TECHNICAL SERVICE BULLETIN

1-C-6

SUBJECT: REAR REFLEX REFLECTOR CAMPAIGN
Campaign Number CCL693

MODELS:
TR-6

TR6 REAR REFLEX REFLECTORS

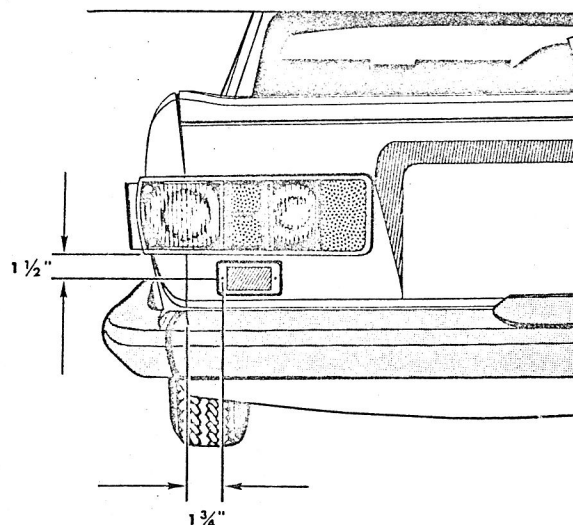
The attached drawing shows the correct location of these additional reflectors (2 per car), which are available from your distributor upon ordering.

On all TR6 vehicles manufactured after January 1, 1970, two additional rear reflex reflectors must be fitted as illustrated below.

The reflectors must be installed in accordance with the dimensions given in the illustration and drilling template below. The wedge-shaped rubber plinth should be fitted between the reflector and the body so that the reflector lies in a vertical plane.

ALIGN WITH LOWER
EDGE OF REAR LAMP FOR L.H. SIDE

ALIGN WITH POINT
LINE OF REAR FENDER

ALIGN WITH LOWER EDGE OF
REAR LAMP FOR R.H. SIDE
